# A FLECK PERFORMANCE BULLETIN

Bulletin No. 332

## 3200 TIMER TO HAVE ADJUSTABLE TIME OF REGENERATION

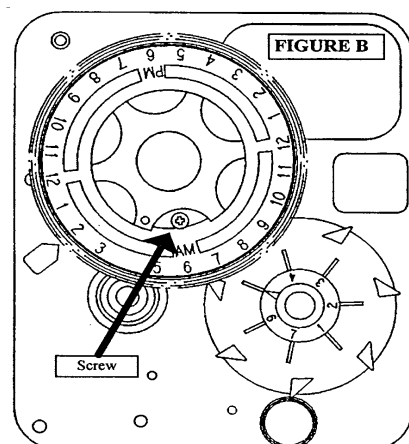
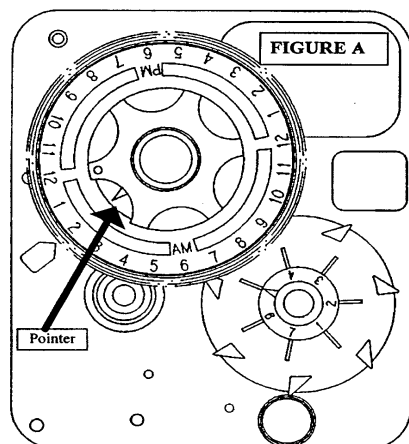
We have redesigned the 24 hour dial of the 3200 Timer so that the regeneration time can be field adjusted. This has been a request from our customers so they can use the 3200 timer in place of the 3000 timer. This change will take place on December 1st.

1. Disconnect the power source.
2. Locate the three screws behind the manual regeneration knob by pushing the red button in and rotating the 24 hour dial until each screw appears in the cut out portion of the manual regeneration knob. (Figure B)
3. Loosen each screw slightly to release the pressure on the time plate from the 24 hour gear.
4. Locate the regeneration time pointer on the inside of the 24 hour dial in the cut out. (Figure A)
5. Turn the time plate so the desired regeneration time aligns next to the raised arrow. (Figure A)
6. Push the red button in and rotate the 24 hour dial. Tighten each of the three screws.
7. Push the red button and locate the pointer one more time to ensure the desired regeneration time is correct.
8. Reset the time of day and restore power to the unit.
